Office of Statewide Health
Planning & Development/FDD
REVIEWED IN ACCORDANCE
THE REQUIREMENTS OF T24.
APPROVED *KS*
9/26/11
CHANGE ORDER# *CO 266*
INSTRUCTION BULLETIN# _____
DEFERRED APPROVAL# _____
APPENDUM _____

12011.00
Increment #7

LEVEL 2
REFLECTED
CEILING PLAN
AREA - C

A4.2C

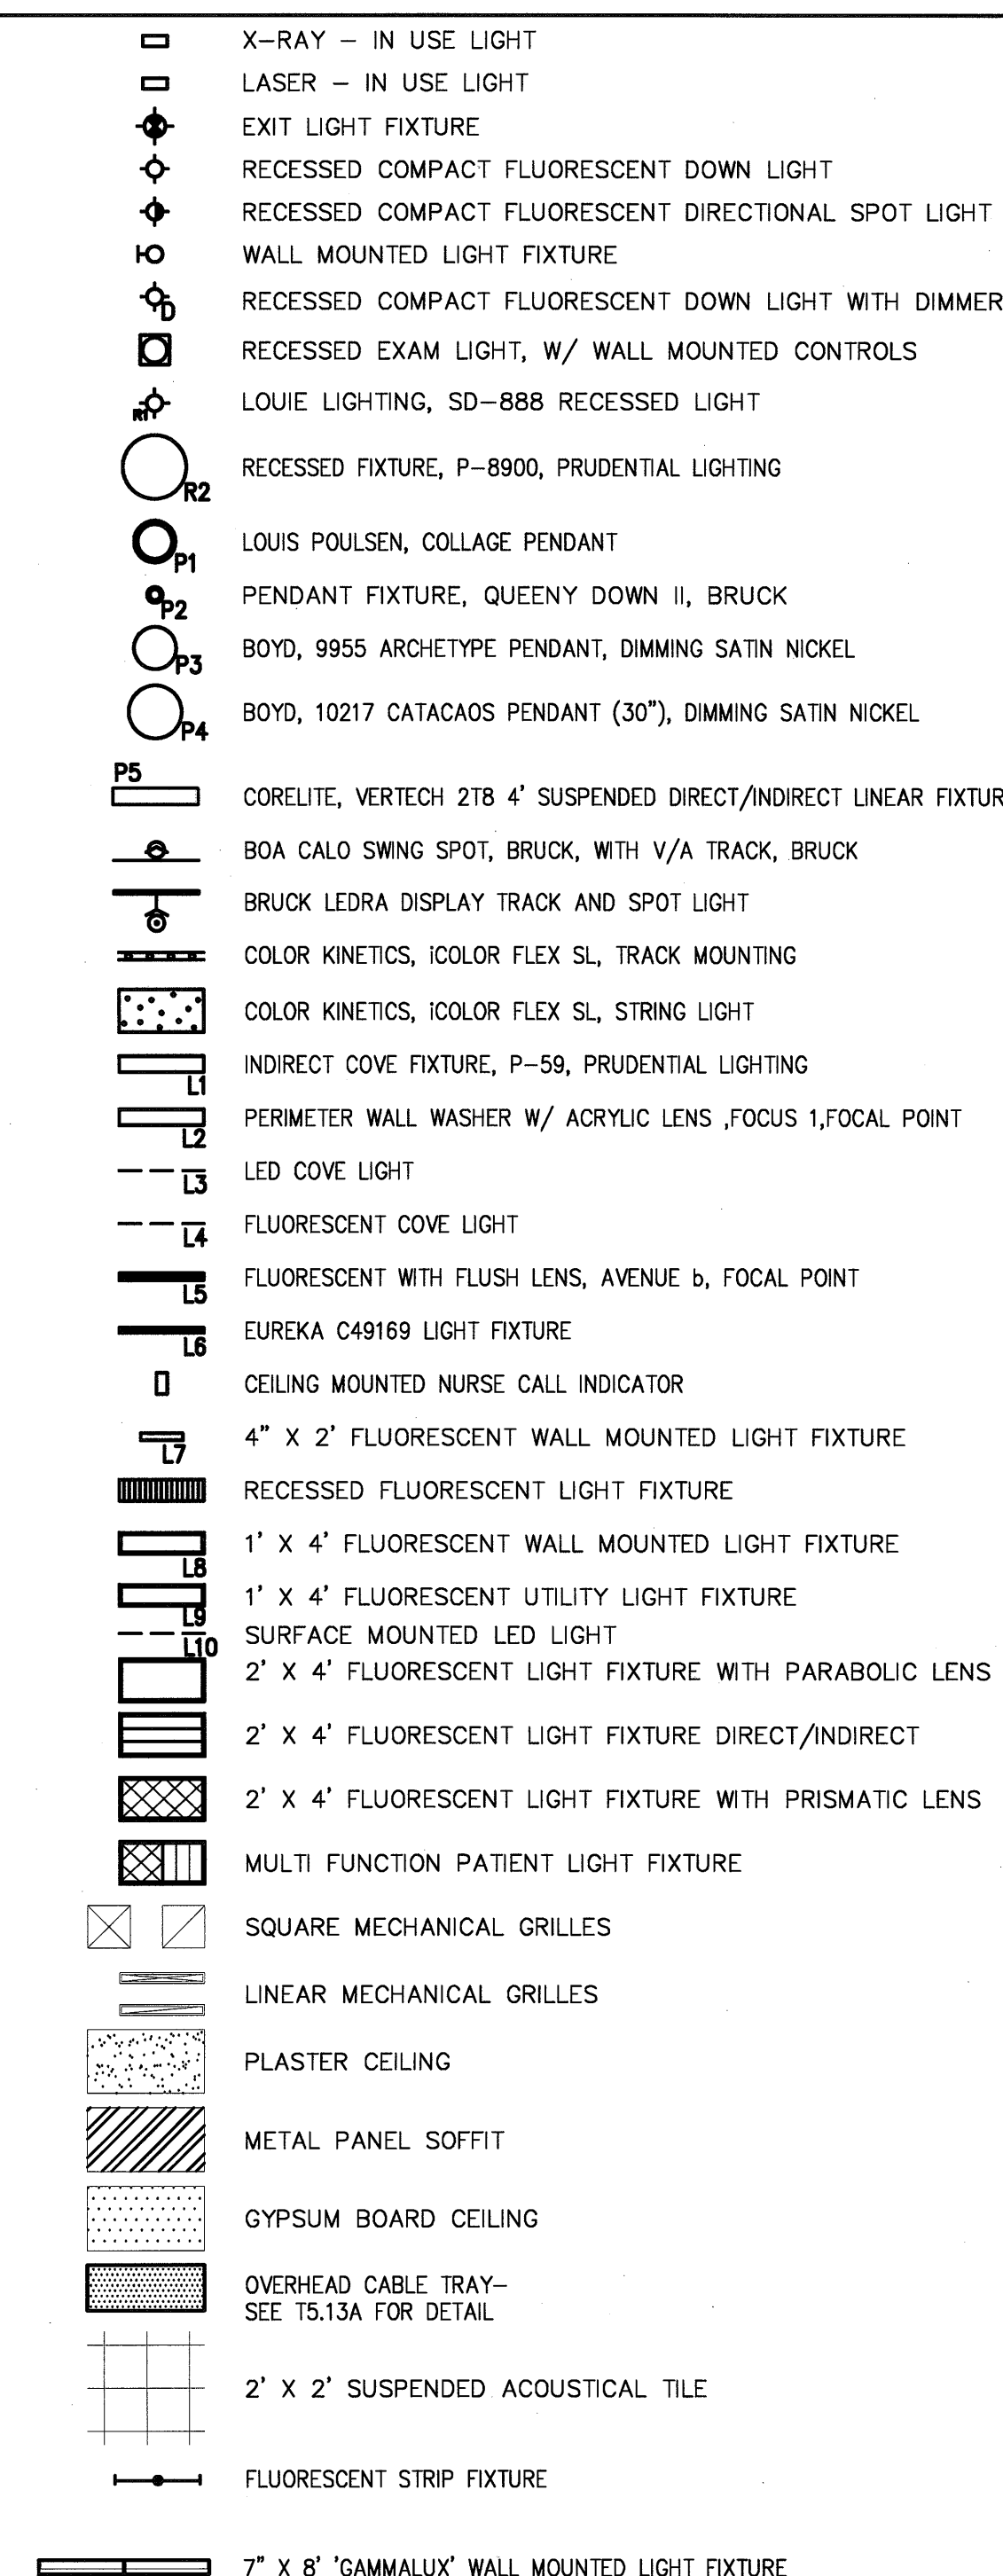
Changes on these drawings do not consist of materially altered changes to approved drawing and don't require a change order.

44	05/28/10	ASI #08
112	10/25/10	ASI #38
168	02/04/11	ASI #57
189	03/28/10	CO #17
161	03/01/11	CO#134
340	09/05/11	CO#266
